Informal document No. GRSG-94-21  
(94th GRSG, 21-25 April 2008,  
agenda item 5.)

Transmitted by the expert from OICA

PROPOSAL FOR DRAFT AMENDMENTS TO REGULATION No. 34

Note:The text reproduced below was prepared by the expert from OICA in order to introduce new parts III and IV into the Regulation, allowing the possibility for approvals to be granted for fuel tanks as separate technical units. The modifications to the current text of the Regulation are marked in **bold** or ~~striketrough~~ characters.

**Model C**

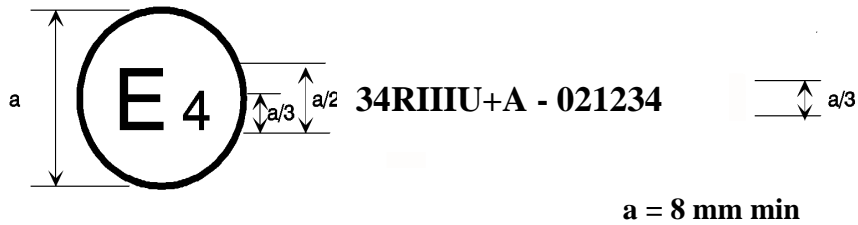
(see paragraph 3.2.4. of this Regulation)

The above approval mark affixed to a fuel tank shows that the type concerned was approved in the Netherlands (E4) pursuant to Part III of Regulation No. 34, for a universal use including its accessories, under approval No. 021234. The first two digits (02) of the approval number indicate that the approval was granted in accordance with the requirements of Regulation No. 34 as amended by the 02 series of amendments.

**Model D**

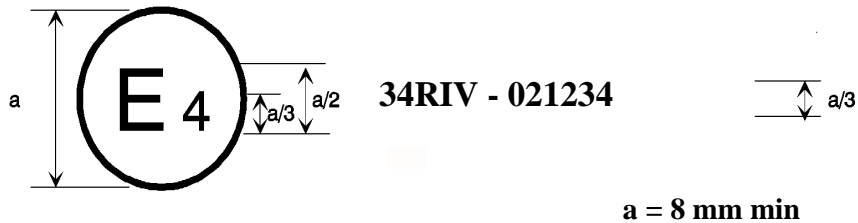
(see paragraph 3.3.4. of this Regulation)

The above approval mark affixed to a vehicle shows that the type concerned was approved in the Netherlands (E4) pursuant to Part IV of Regulation No. 34 under approval No. 021234. The first two digits (02) of the approval number indicate that the approval was granted in accordance with the requirements of Regulation No. 34 as amended by the 02 series of amendments.

**Model E**

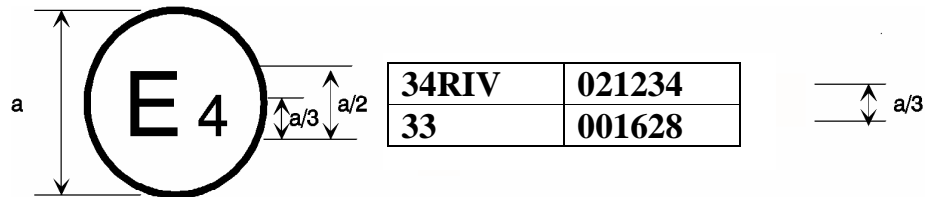
(See paragraph 3.3.5. of this Regulation)
